**SUPPLEMENT TO INVITATION FOR BID – April 4, 2019
City of Craig**

**CRAIG NORTH COVE HARBOR LIGHTING REPLACEMENT
RESPONSE TO QUESTIONS AND ADDENDA ITEMS**

Sheet E1, GENERAL NOTES AND LEGEND

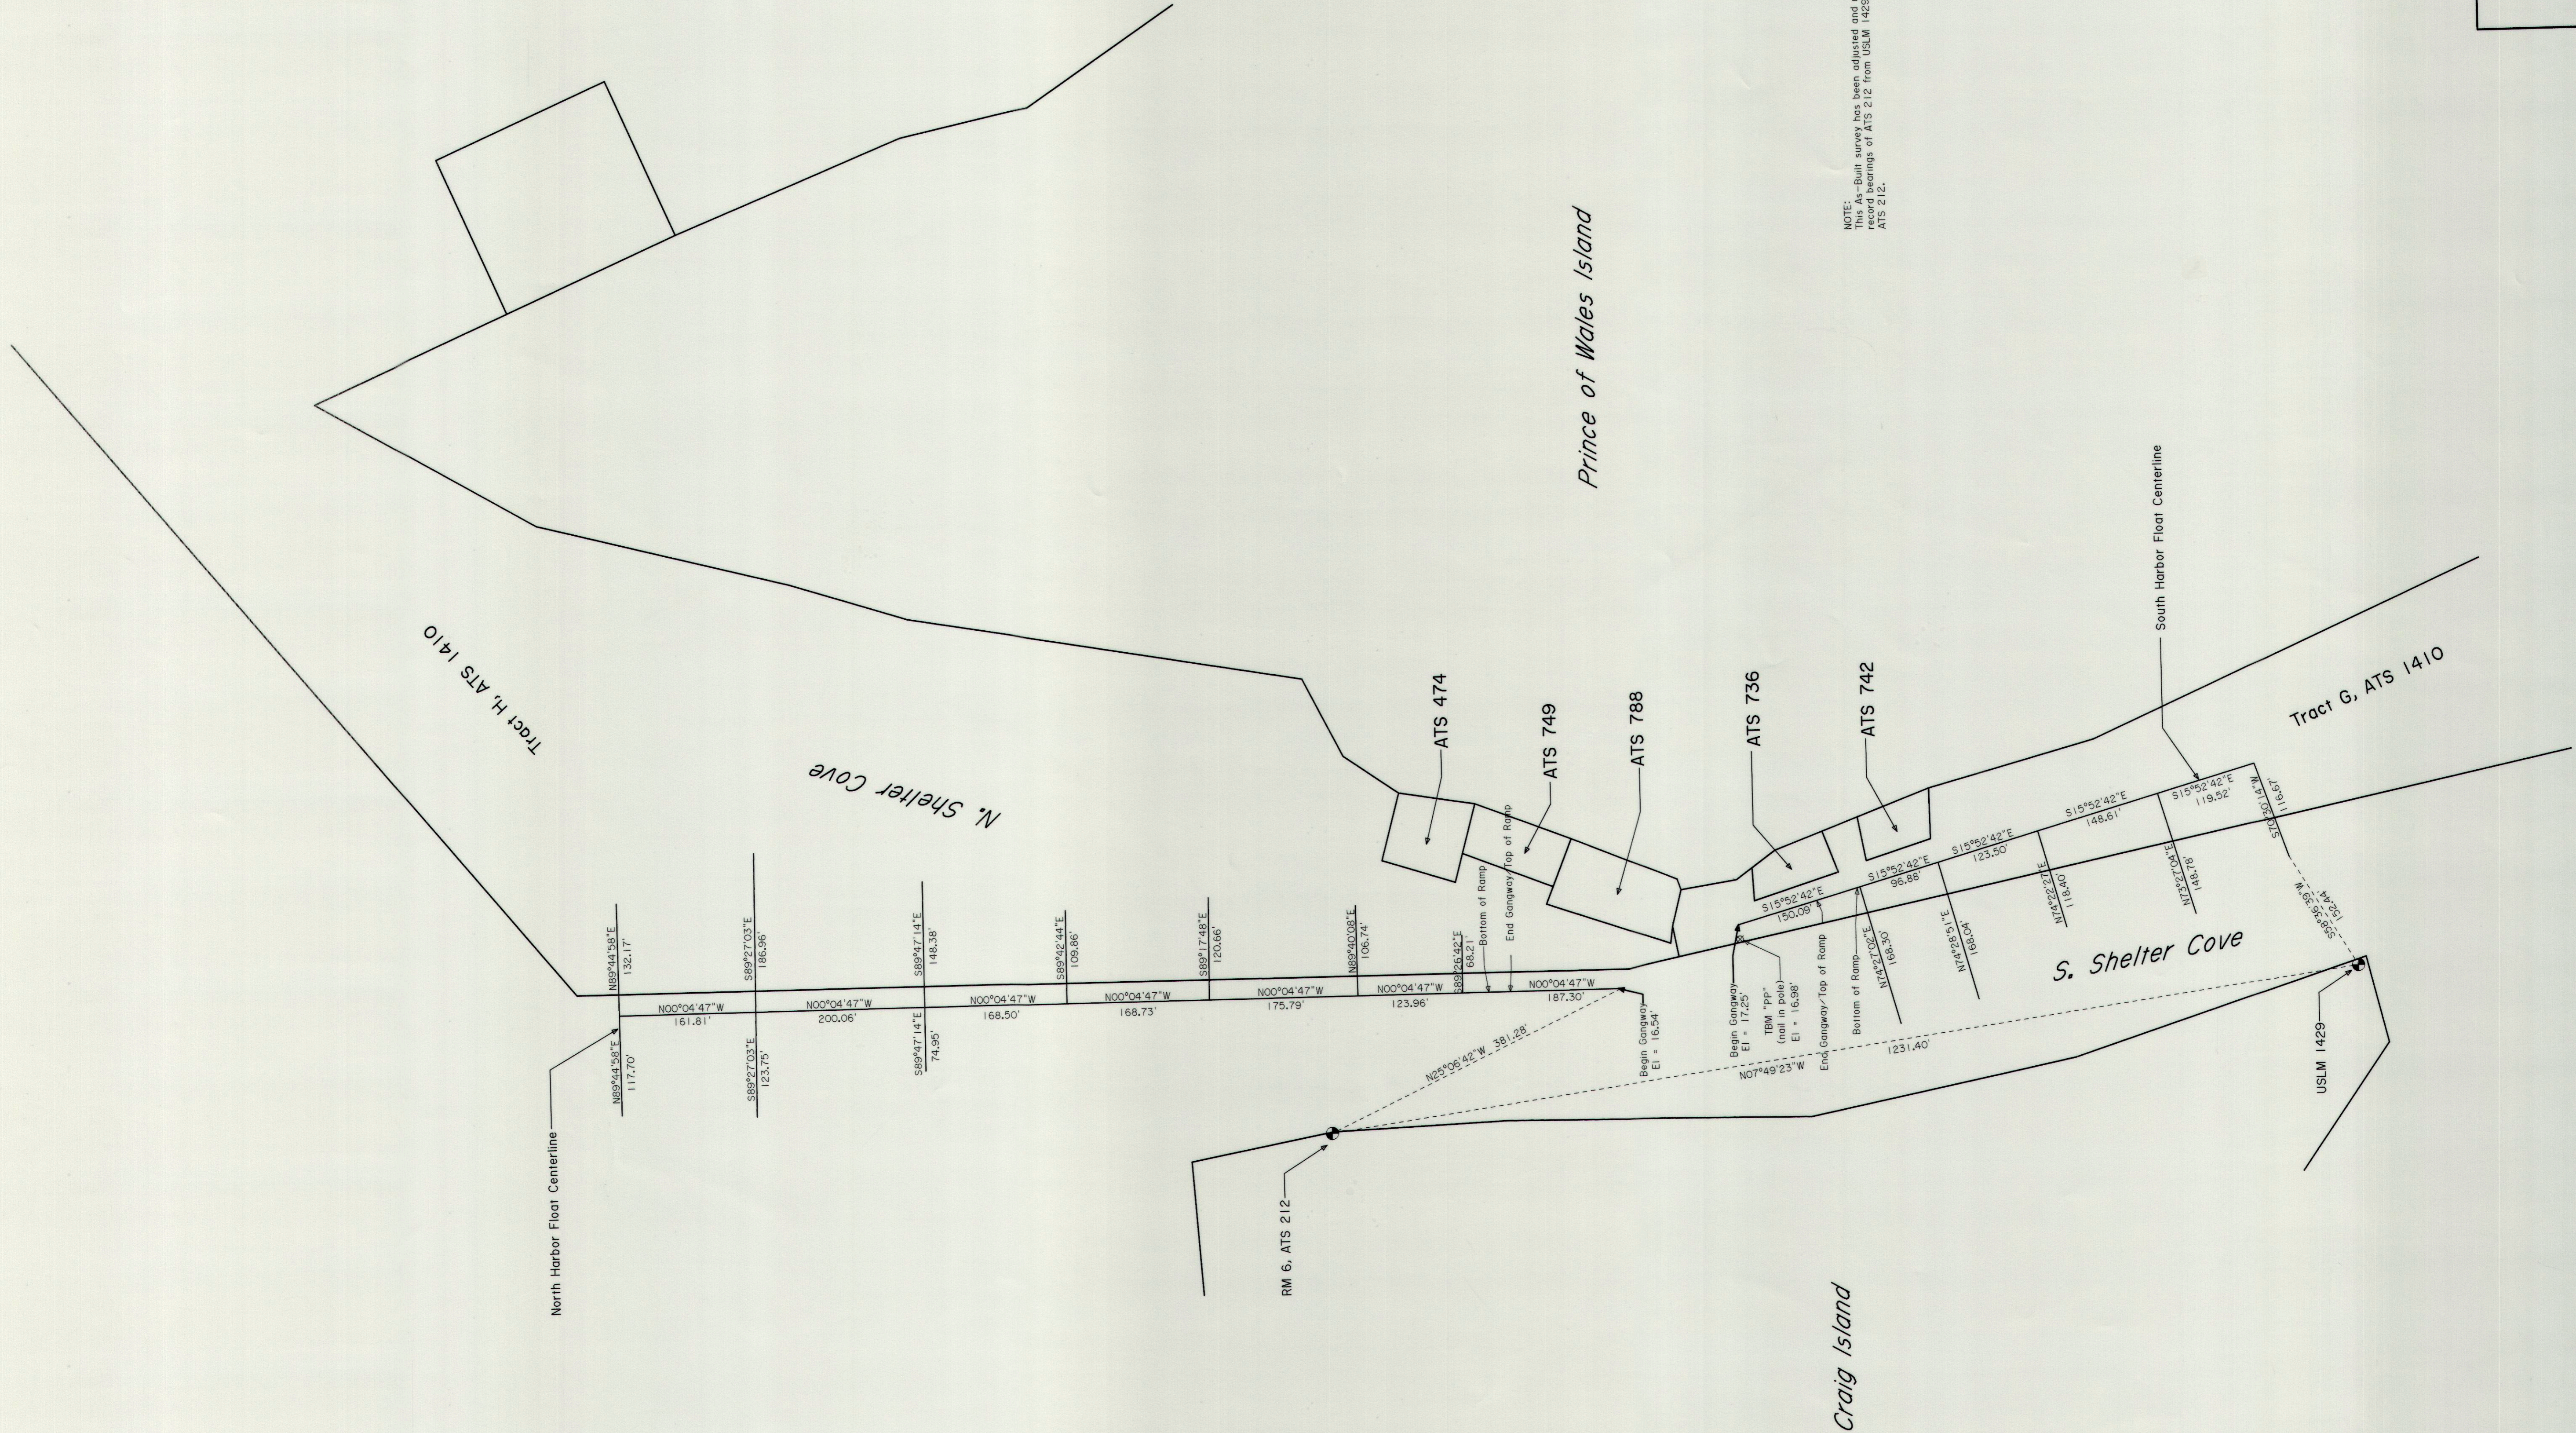
Q5. On plan page E1 General note 6. "All conductors shall be copper ", On plane page E2 note 3. says to provide triplex overhead cables using code word CONCH, this is an alum #2 triplex with the ASCR messenger. Please clarify if this is indeed to be aluminum triplex or is copper to be used? Also can it be from company's other than King Wire Co. if they are equal cables?

Q6. I am not having any luck finding stainless steel pole stand offs, will hot dip glav be allowed on the service pole?

Add the following to note 6: "THE TRIPLEX OVERHEAD CABLE MAY USE ALUMINUM CONDUCTORS, SEE NOTE 3, SHEET E2."

Add the following to note 10. "HOT DIPPED GALVANIZED SUPPORT CHANNEL STANDOFFS ARE ACCEPTABLE FOR THE UTILITY POLE"

AS-Built Survey:

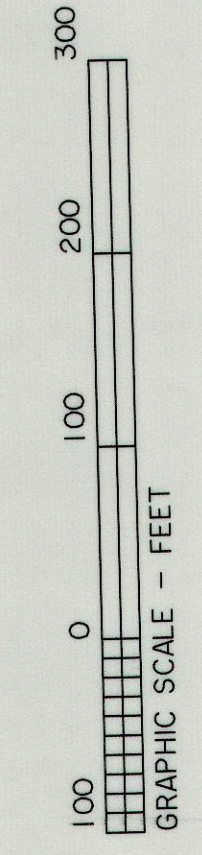
Q4. As there is no scale on the drawings, what is the length of the dock?

Response: A scaled, as-built drawing of North Cove Harbor is attached.
